Breeze effects at a large artificial lake: summer case study

AUTHORS' RESPONSES TO THE ADDITIONAL REVIEWER 1 COMMENTS

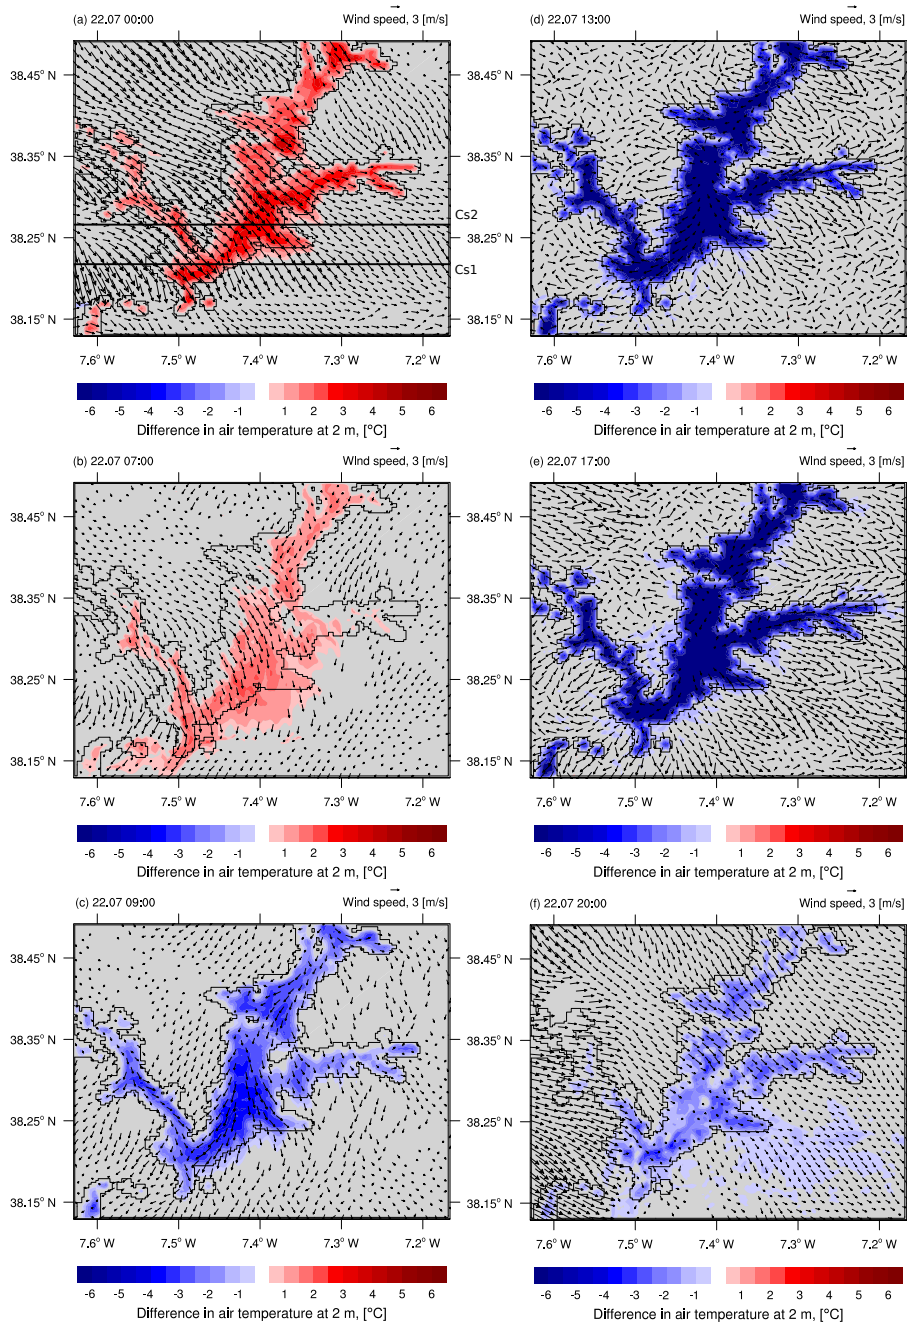
You named (as the referee 2 asked) the cross sections to S1 and S2. This is a bit confusing when you also cite supplementary figures S1 and S2. I would change the references to the cross sections to something else (I recommended roman numbers I and II in the first phase). Actually, it would be nice to see the names of the cross sections in the figure as well (next to the lines).

Response: Cross-sections were renamed to Cs1 and Cs2 to avoid confusing and corresponding labels added to Fig. 9:
